**WEEDON PARISH COUNCIL**  
**CLERK TO THE COUNCIL MRS RUTH MILLARD**

**Ref: Weedon Parish Council's response to planning application:**  
**13/03534/AOP Land East of A413 Buckingham Road and Watermead**

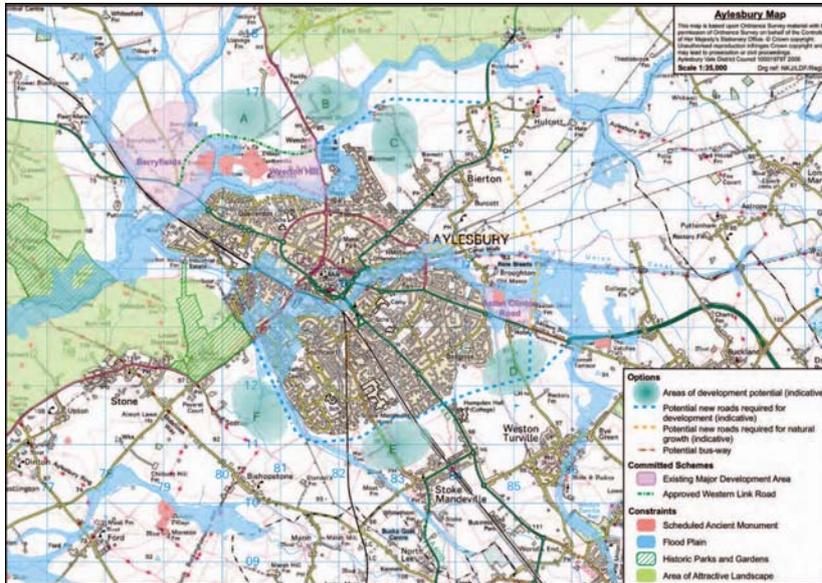
- 8.2 We draw your attention to the conditions of flood seen in the recent wet weather (December 2013/January 2014), in the flood-plain of the River Thame on the project site and to either side of it. There has been substantial standing water around the river.

A little further along the River Thame to the south, between the edge of Aylesbury and Buckingham Park, the flood-plain has a footpath/cycle path running through it, which provides pedestrian and cycle access to Aylesbury from Buckingham Park. The whole area, including the path, has been under inches of water on several occasions, for days at a time, making it completely unuseable.

Building a major road through a similar section of the flood-plain would seem to present significant difficulties if the road were not to be subject to the same potential hazard.
